66104A-09A

S E R V I C E N O T E

66104A DC Power Supply

The instrument will not communicate or will not complete self test.

Figure 1

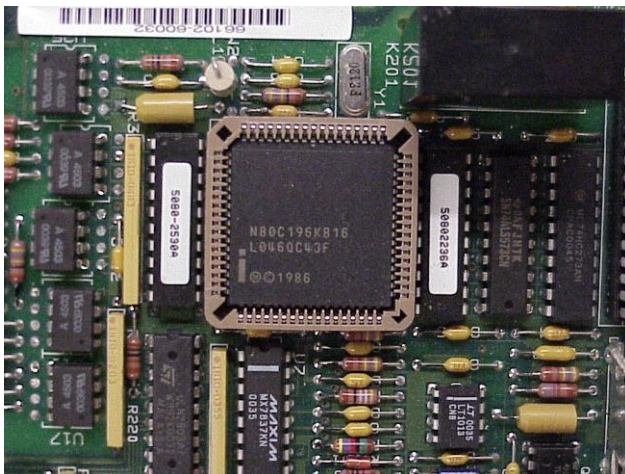
Figure 1 will help to identify the **68-PIN PLCC SOCKET location - P/N 1200-1274** (Circuit Reference “U001”)

Any Model having a serial number starting and ending with the serial numbers shown in the chart below should have the socket 68-PIN PLCC SOCKET - P/N 1200-1274 (Circuit Reference "U001") **REPLACED!**

Figure 2

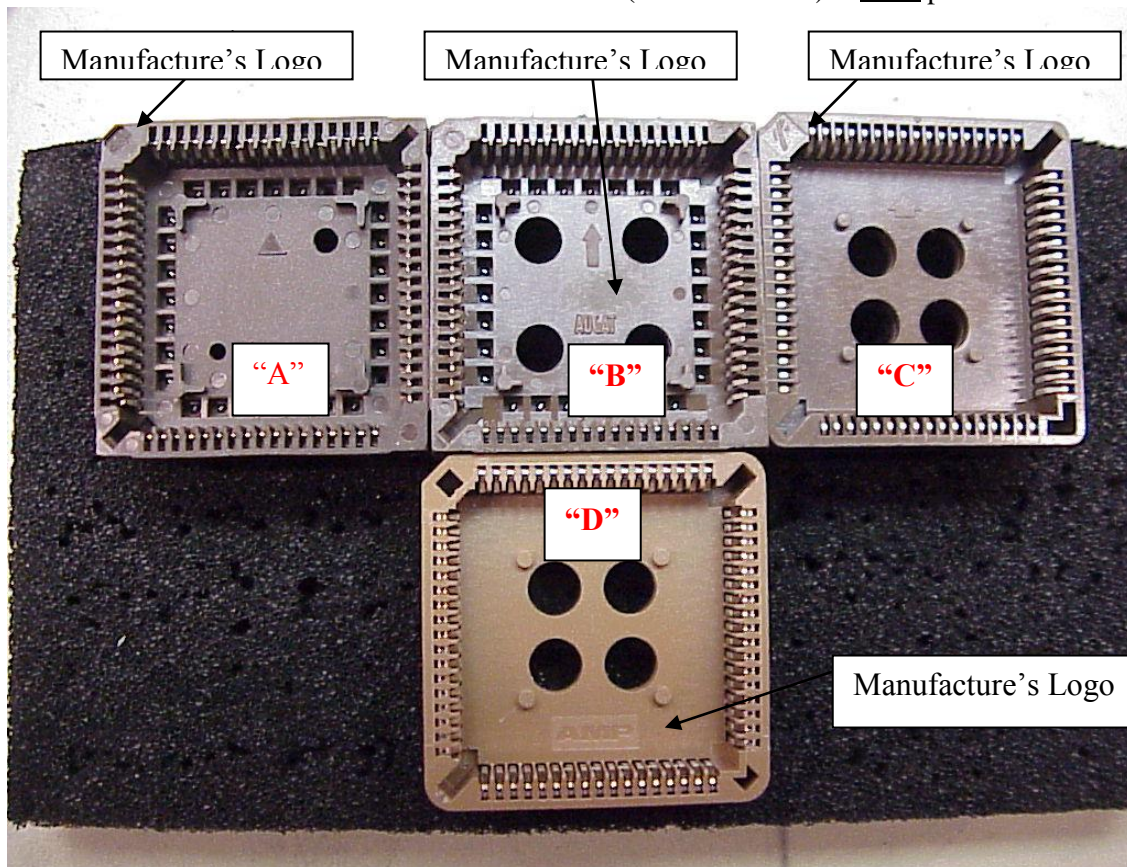
This figure should be used to identify **GOOD** sockets and a potential defective socket. The **16-Bit MCU 16 MHZ 68PLCC CMOS IC (P/N 1821-1479)** is **NOT** pictured.

- Socket **"A"** is a sample of a GOOD AMP socket.
- Socket **"B"** is a sample of a GOOD Tyco/Augit socket.
- Socket **"C"** is a sample of a GOOD FCI socket.
- Socket **"D"** is a sample of a DEFECTIVE Tyco socket.

The sockets above labeled **"A", "B" or "C"** are good and should NOT be replaced.
The socket above labeled **"D"** is considered defective should be replaced.

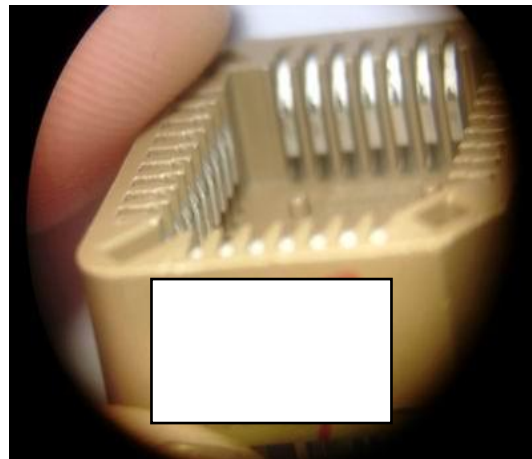
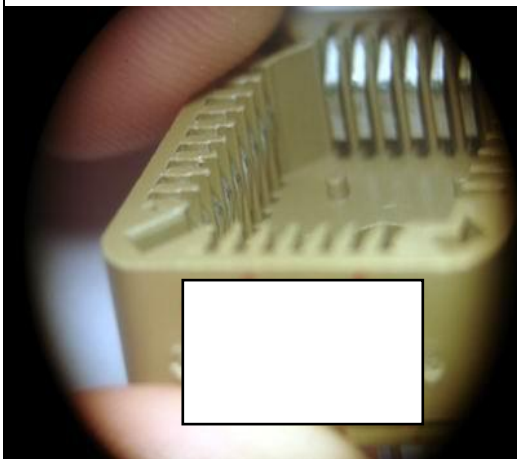
The condition of the recessed beams has been corrected by a design enhancement implemented in production. This design enhancement increased the spring height dimension by 0.04mm and decreased the spring height tolerance by 40%. The spring height dimension is shown in the drawing below.

This design enhancement is intended to position the contact beams closer to the middle of the socket and increase the normal force exerted on the contacts of the chips mated to the socket.

The effectiveness of this design enhancement was tested by comparing the mating and un-mating forces on the older and newer designs. The test results for sockets with the increased spring height (newer design) showed an increase in the mean mating force of 18.9% and an increase in the mean un-mating force of 23.4%. The increase in the un-mating force test results between the old design and the new design indicate that a greater normal force is being exerted on the test chip contacts by the socket contact beams. The two revisions of this contact beam design were visually examined after the mating and un-mating force testing. Photos of the two sockets are shown below. The photo on the left shows the older version socket prior to the enhanced contact beam design. The photo on the right shows a socket with the design enhancement. The contacts with the older design appear to be recessed farther into the housing after un-mating.

Material with this design enhancement will be labeled with a 2007 date code
